FULL PROPOSAL FORM

Lewis River Aquatic Fund

Lewis River 21 Phase II

Questions asked from USFS Lewis River 21 Phase II Final Draft Proposal

Figure 1. Lewis River Phase II proposed project location, North Fork Lewis River, Skamania County, Washington (Lat/Long: 46.078683, -121.929327).

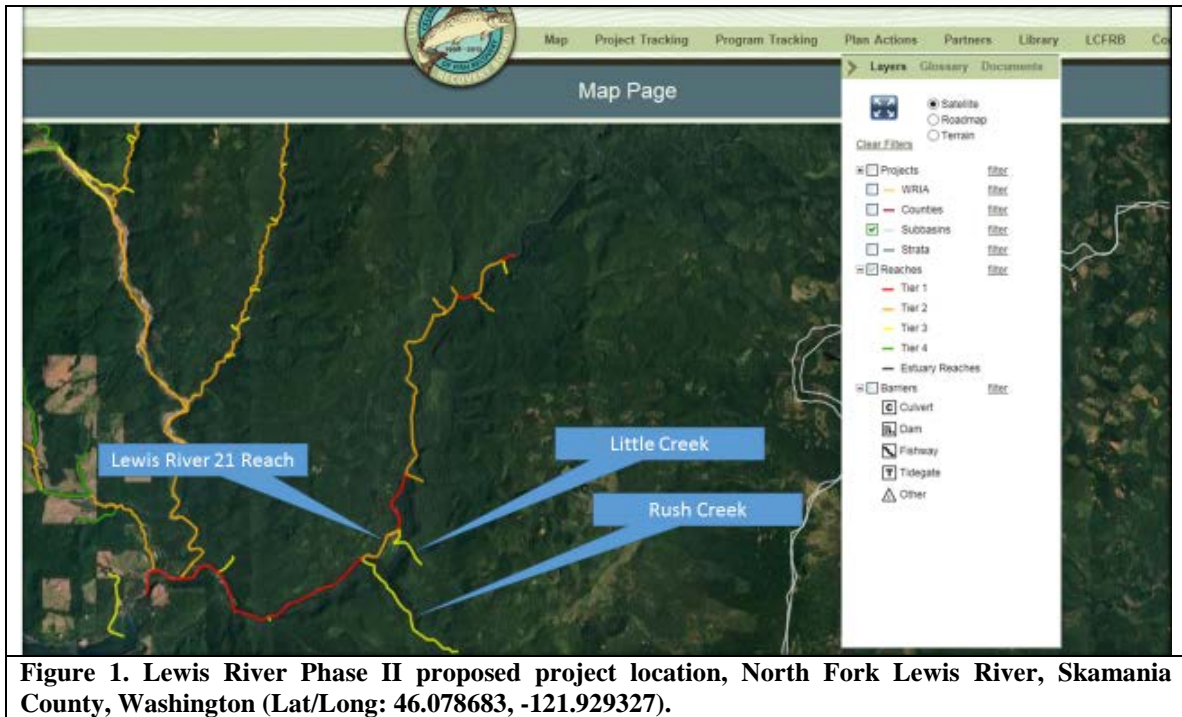
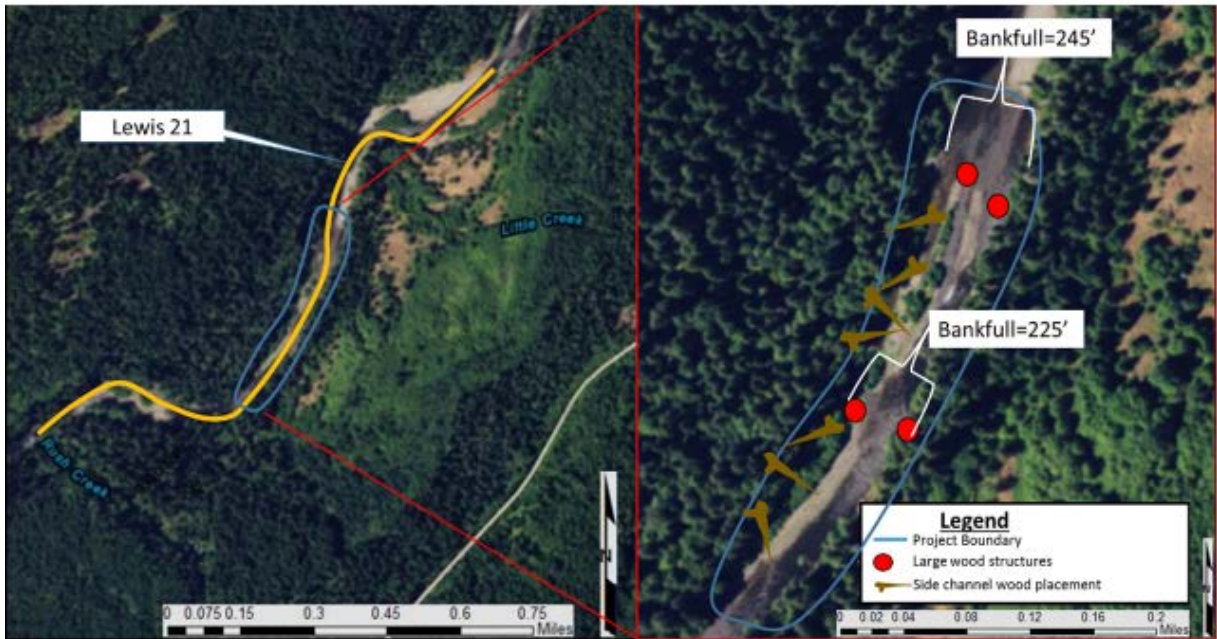
Comment 2. Aerial photos with the location of the proposed structures along with existing jams should be included in the final proposal.

Aerial photos have been included in the Final Proposal (Figure 1 and 3). These have been included in the Pre and Final Proposal compilation. The existing wood jams are non-embedded pieces of wood on the surface of the vegetated island at the same location where the Apex large wood structures are designated.

Comment 4. Where are the existing wood complexes in relation to the four new structures being constructed? What will happen to the existing structures i.e. will they be dismantled then rebuilt?

The existing wood on the vegetated island were deposited from the 50 year high flow event in December 2015 and are located in the same area that the upper Apex Jam will be constructed. Figure 3 shows the wood in relation to the channel. These pieces of wood are not imbedded in to the channel and are highly mobile in nature. If these pieces are still in place during implementation they will be incorporated into the constructed structures unless the wood is not structurally sound in which case, they will be used as floodplain roughness elements and or mulch for soil disturbance.

Figure 4. LiDAR elevation map showing structure locations (red dots), and future small channel areas (dashed red line). Excavation of the small channel inlet areas will be limited to 30 feet from bank edge and allow access of bankfull flows or greater.

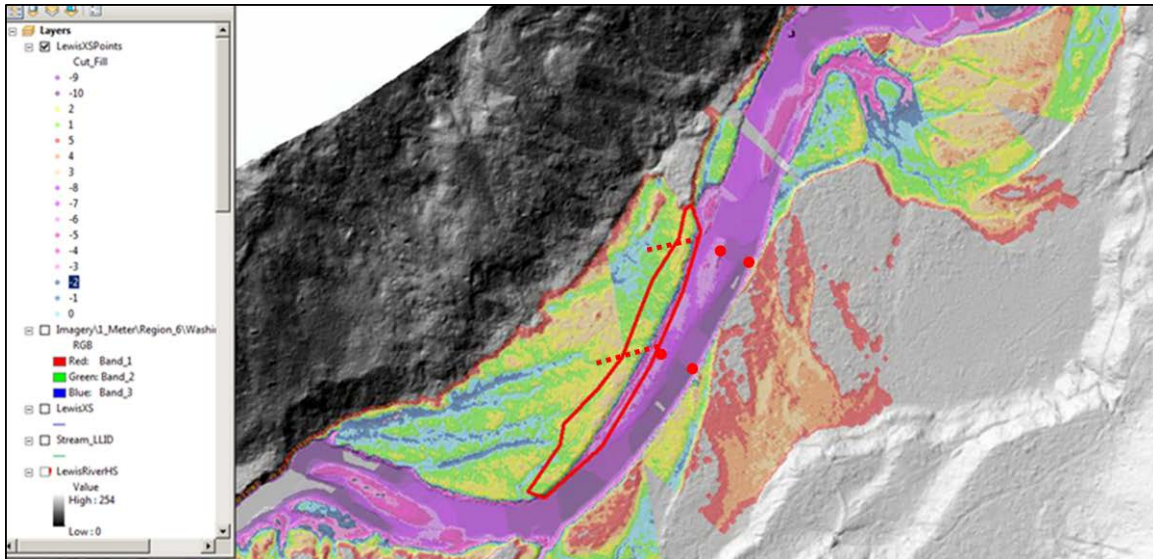
- 1) **Both figures 1 and 2 in the full proposal document show the right bank side channel bed elevation as higher than the current main channel bed elevation. The proposed apex and bank structures would engage with flows in the main channel at elevations much lower than the side channel. Diversion of flow into the side channel would only occur at approximately bankfull (Q1.2) or higher flows. By constraining channel forming flows in the main channel up to bankfull elevation, what is the risk of causing vertical channel incision that could further disconnect side channel habitat? Is excavation proposed to ensure side channels will be activated at less than bankfull flows? If so, this should be shown in the project drawings. It is important to engage side channels at flows both above and below bankfull elevations because of the year-round needs of reintroduced species for complex, off-channel rearing and spawning habitat.**

Excavation of the inlets to the small channel entrances to the floodplain will be at elevations to allow for bankfull or higher flows. We have changed Figure 4 title to more accurately describe the proposed actions. We recognize the importance to engage these small channels in the floodplain at flows below bankfull elevations and will re-evaluate the inlet elevations during the Lewis River Phase III Design and after risk to the trail can be addressed and implemented.

Figure 4. Cross section of upstream apex and bank structure noting structure footprint, design discharges, and bankfull width.

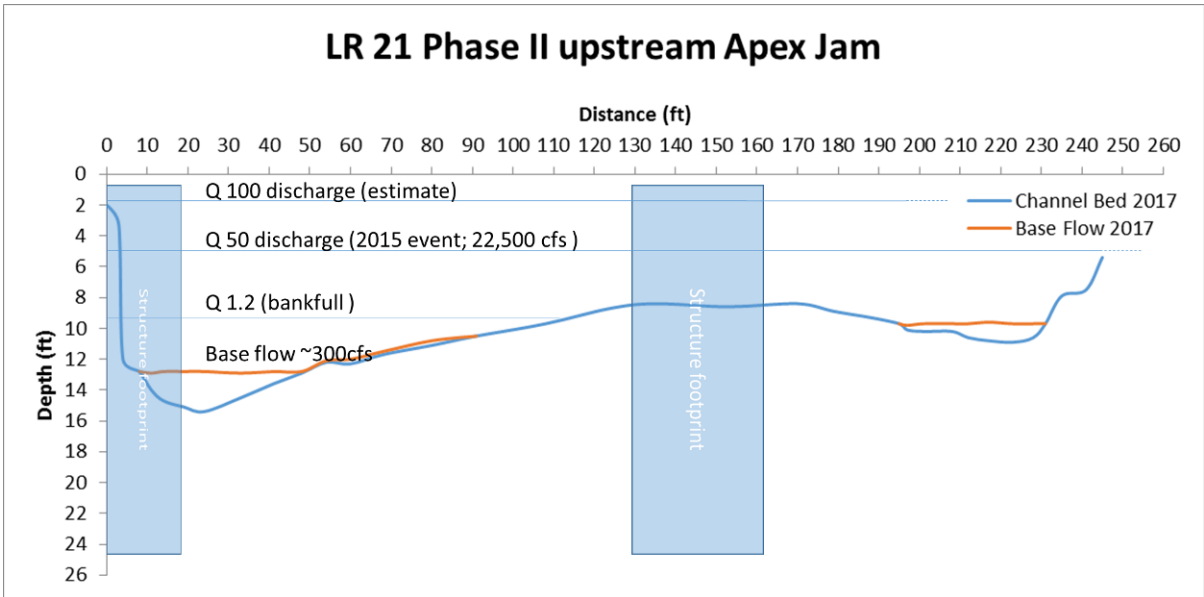
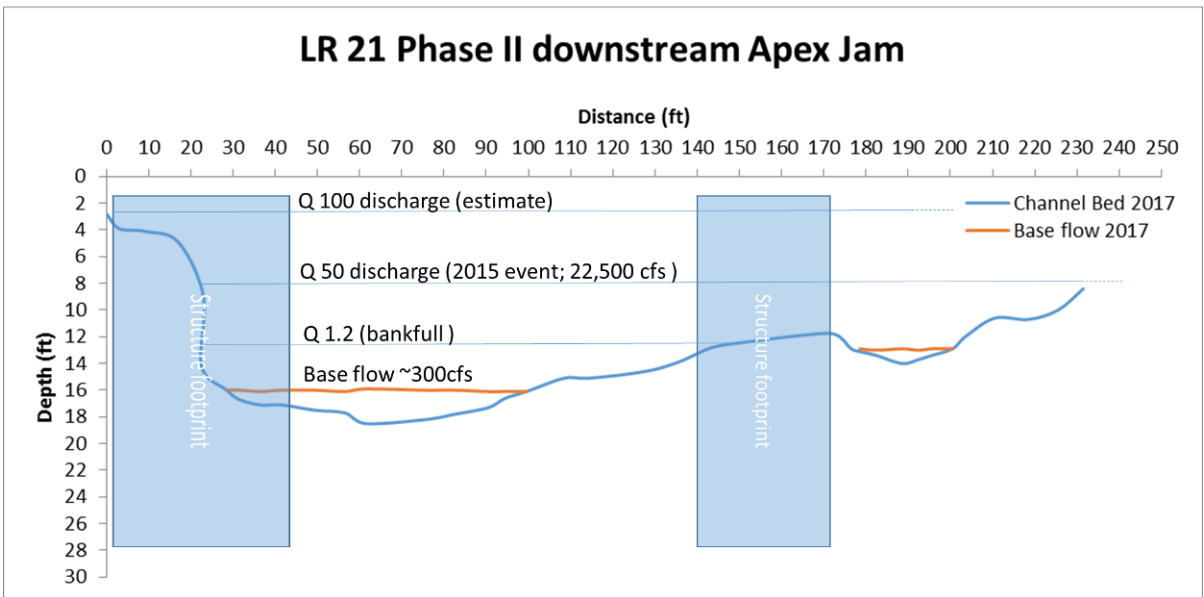
As discussed in the January ACC meeting, the cross sections provided in the full proposal suggest that structure placement may encourage greater scour, rather than floodplain interaction, depending on several factors, one of which is whether pre-excavation occurs in side channel areas. The proponent stated that recreational resources may be impacted by excavation, which suggests that if the project functions as designed (regardless of excavation), recreation resources may be constraining. This should be fully explained.

Local scour will occur through constriction scour between the bank and apex structures and the constriction will raise the hydraulic gradient upstream of the two bank and apex structures to maintain side channel function in the long term.

Figure 8. Relative Elevation Model map of the Lewis River Project Valley. Legend for color codes is displayed in the GIS table of contents at the left.

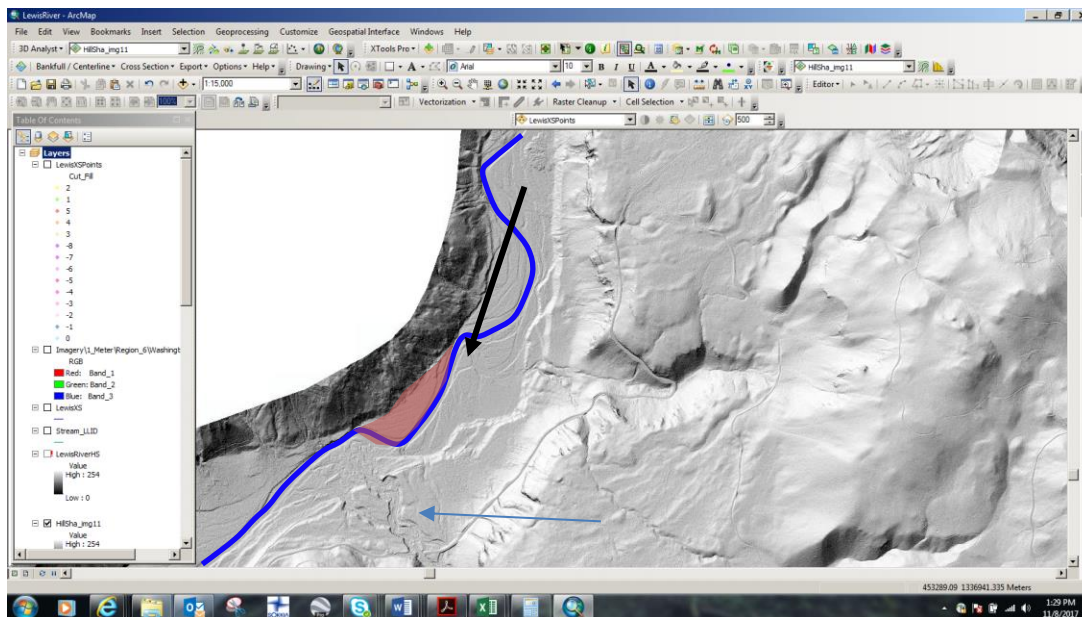
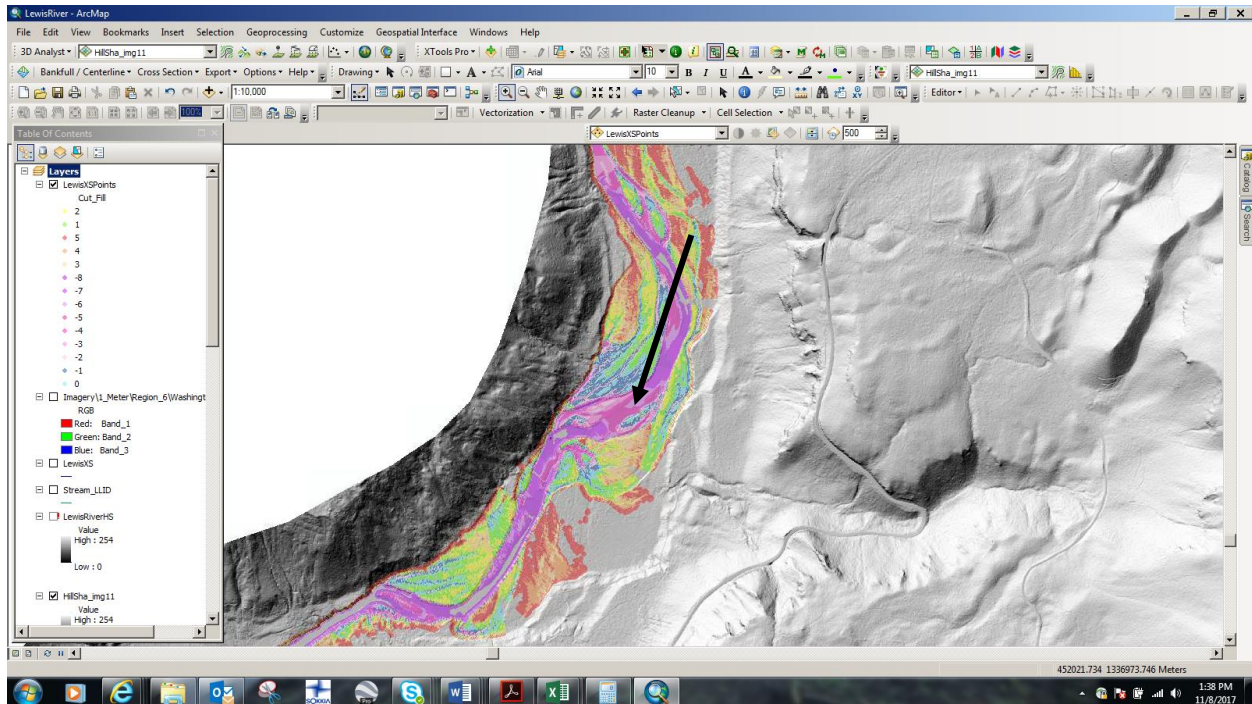
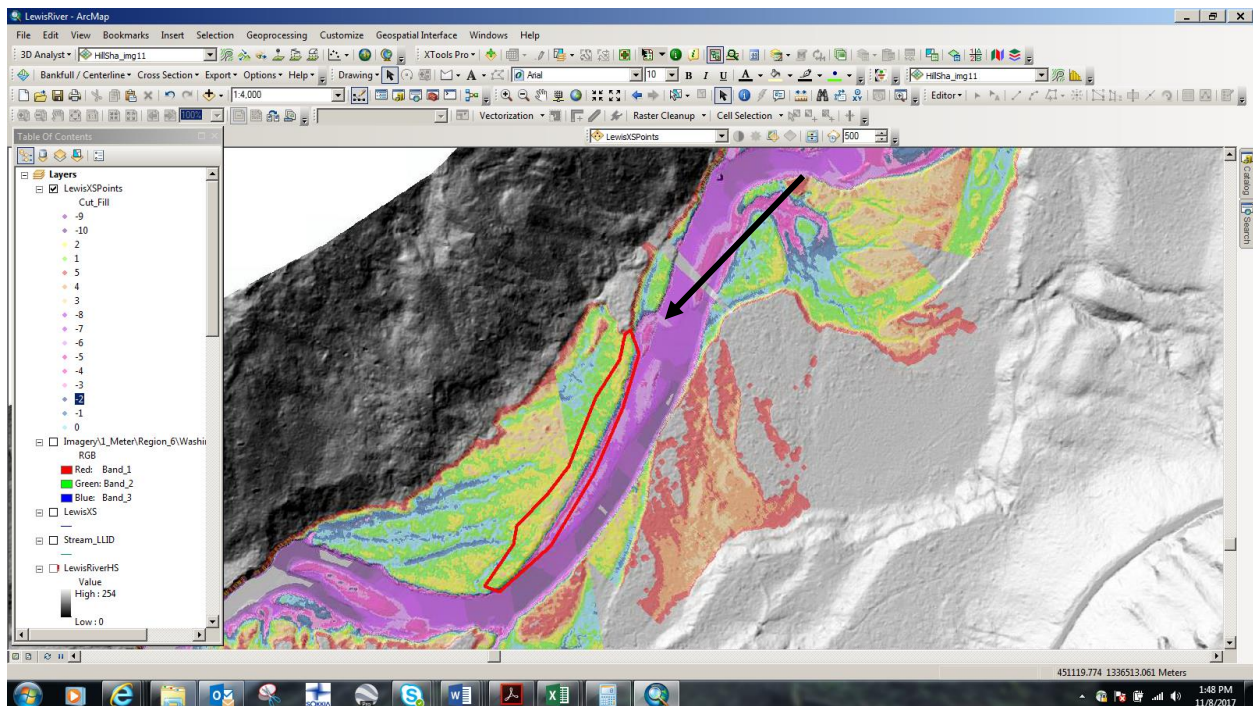
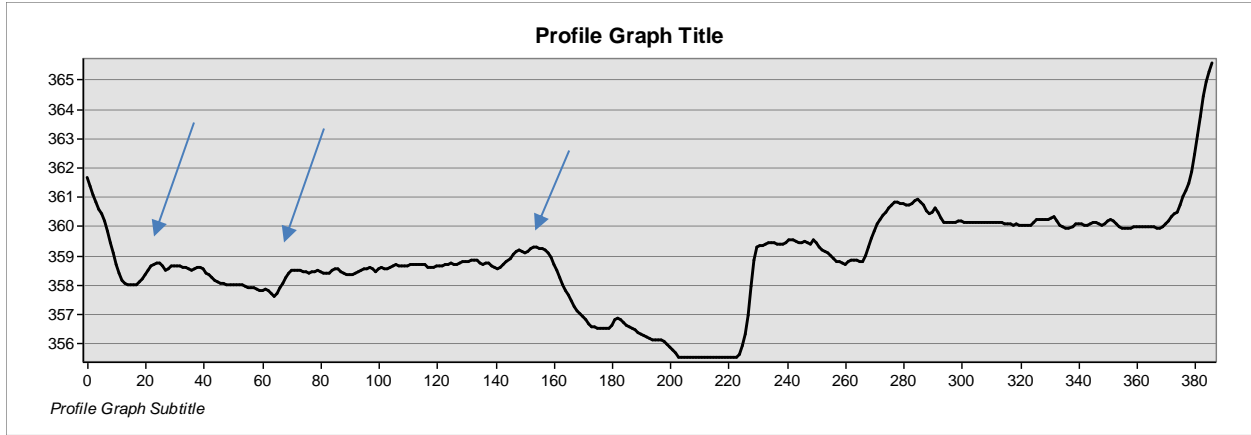
We think that the project as proposed would improve connectivity to disconnected surfaces and channels as well as provide some much needed habitat complexity within Lewis River Reach 21. The proposed placement of LWD with the addition of key members (up to 36 inch dbh) would provide the roughness needed to displace some amount of water volume and seasonally wet, to some extent, disconnected channels on river right. The proposed construction technique has proven effective at displacing flow, promoting pool formation and promoting the deposition of alluvial substrates around and behind the structure.

Given the track record of the proposed approach as well as the practitioners involved in the project development, it seems highly likely that the proposed project would be effective at improving mainstem Lewis River habitat including pool formation and deposition of alluvial substrates as well as improving connectivity with the disconnected historic surfaces.

We also recommend maximizing the extent and duration of the connectivity initiated with this proposed project by suggesting additional projects to move the Lewis River to Stage 0. If we presume that the historic conditions found within the valley of the Lewis River resembled the illustration in figure x, and that the current conditions resemble the illustration in figure y, then the degree of departure from historic conditions can be established and a larger scale recovery plan developed. Given that the Lewis River is currently at Stage 3 and resembles the conditions depicted in Figure x, the amount of time needed to reach Stage 0 without direct intervention could be decades or centuries.

Specifically, we recommend aggrading the Lewis River to the PowerSlope elevation. Reconnecting the adjacent valley floor surface by aggrading the bed and removing floodplain and relic channel constrictions significantly reduces unit stream power allowing gravels and silts to deposit on the bed and floodplain. To maintain this elevation, the river should be aggraded at least 2 meander bends upstream or further (extends into Lewis River Reach 22) to allow the river to release its energy on the larger floodplain surfaces. Immediately downstream of the Rush Creek confluence, the Lewis River has cut down to bedrock and this is a good area to develop as a grade tie in location. Reinforcing this grade control with large wood structure is recommended which we understand is planned for in the Lewis River 21 Phase I project scheduled for implementation in the summer of 2018.
